# Manual 14-D

## Generator Operational Requirements

### Revision 49

Vince Stefanowicz  
Sr. Lead Engineer, Generation  
System Operations Subcommittee  
Operating Committee  
June, 2019

# M-14D – Changes Specific to ESR Participation Model - Metering

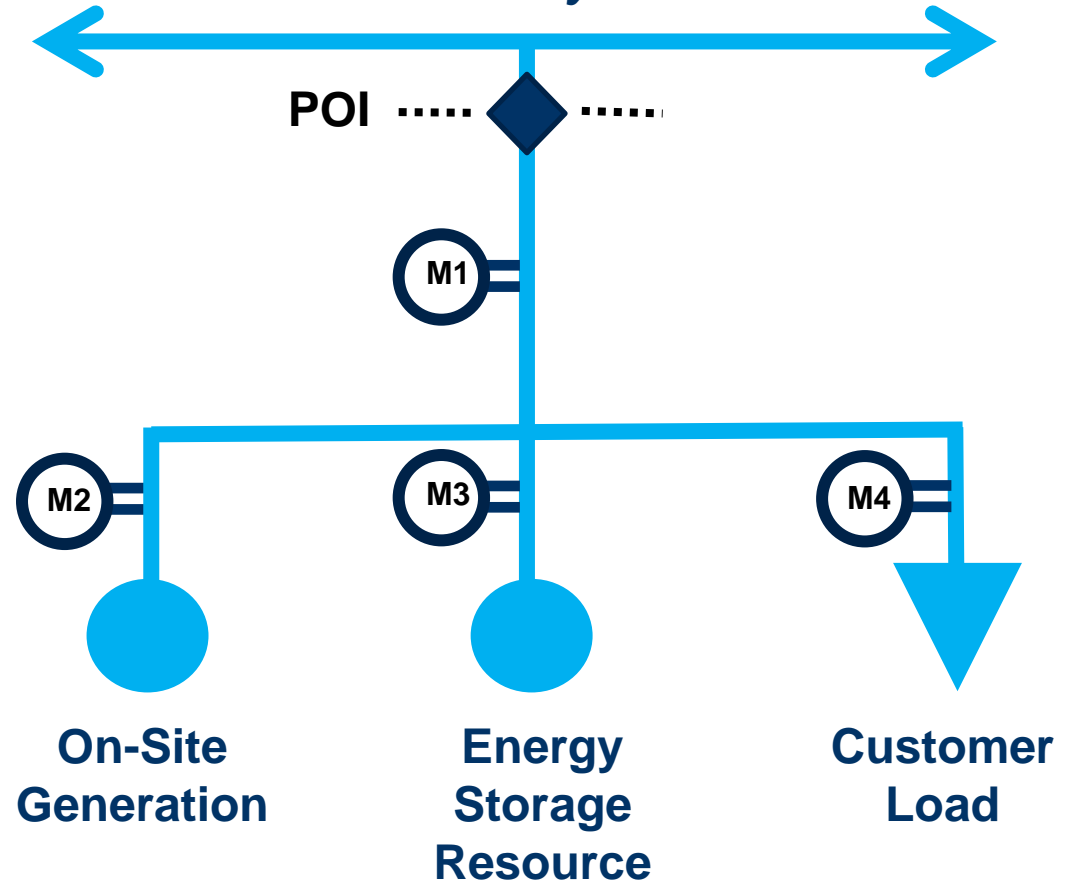
Number and location of measurement devices required will vary depending on how ESR operates

Energy Storage Resources that are co-located with end use load that is not Station Power shall provide a device for measurement of MWh located directly on the Energy Storage Resource terminals (M3 in diagram at left.)
